RE: Response to Comments, Form 28 for the Spadafora Water Storage Facility ID 440177

I have attached our response to comments for the Form 28 for the Spadafora Water Storage Facility, Facility ID 440177.

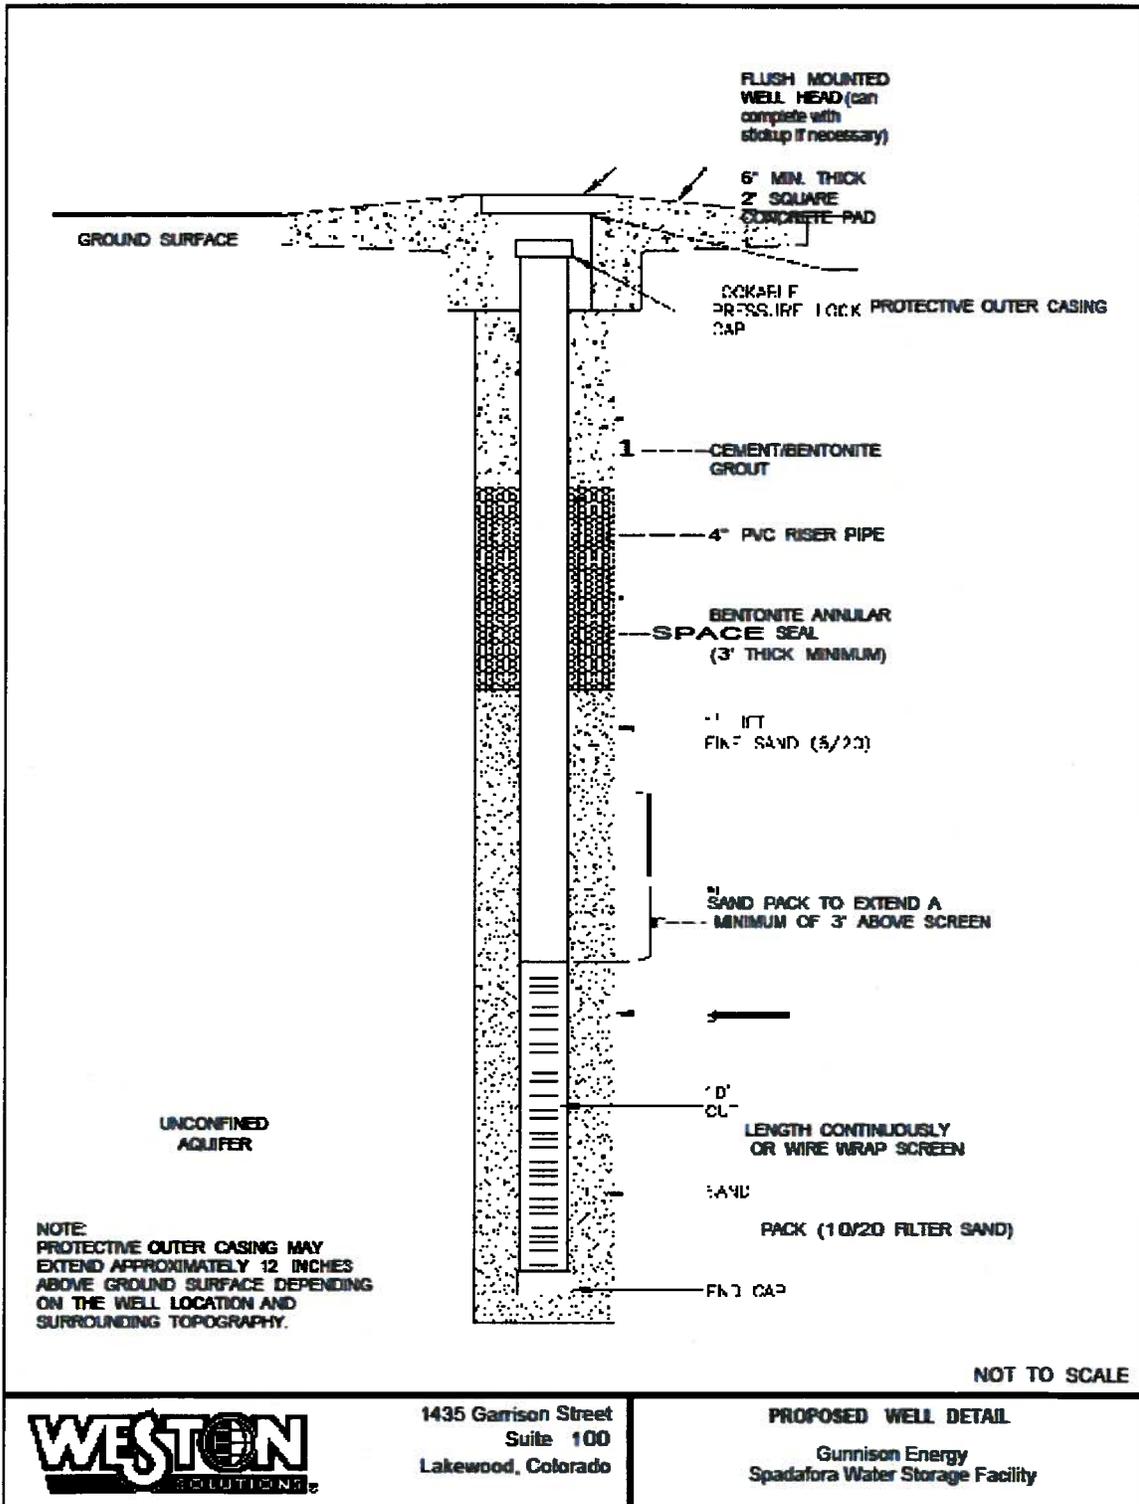
COGCC Comment: : Please submit proposed construction drawings for the monitoring wells.

COGCC Comment: What are the construction details for the five (5) proposed monitoring wells? The static water level in the water well located approximately ½- mile west to southwest of the proposed Facility is 128-feet.

Response: See attached Figure.

Response: See attached Figure
